REMARKS

HP-100203160

FIG. 4A

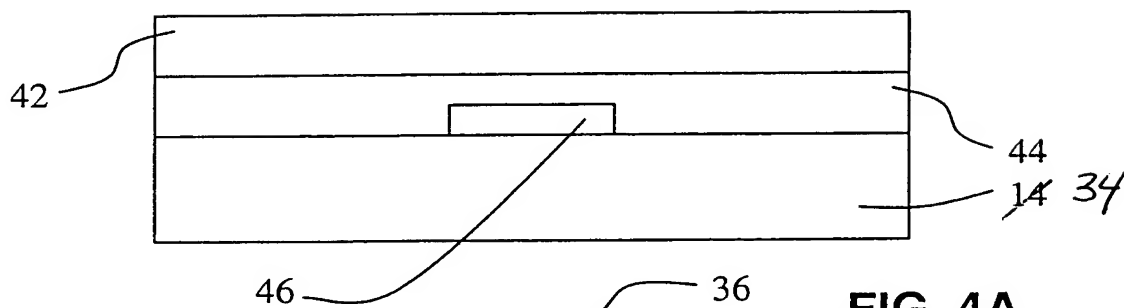
There are objections to the drawings. The examiner did not find a description of item 48 in FIG. 4C. The examiner's attention is direct to the paragraph beginning at the bottom of page 8 which identifies item 48 as the solution processed thin film transistor. Regarding FIG. 4A, a proposed drawing correction is submitted to change "14" to "34" as correctly observed by the examiner. The examiner did not find a description of item 40 as shown in FIG. 5B. The examiner's attention is directed to repeated references in the specification the "transistor channel 40", including in the paragraph discussing FIGs. 5A – 5C on page 9, e.g. at line 30. A proposed amendment to FIG. 5B changes numbers 10 and 12 to 30 and 32, consistent with the specification and FIG. 5C. This addresses the objection to FIG. 5B. Substitute formal drawings including the proposed changes are also submitted herewith, and acceptance is requested upon approval of the proposed changes.
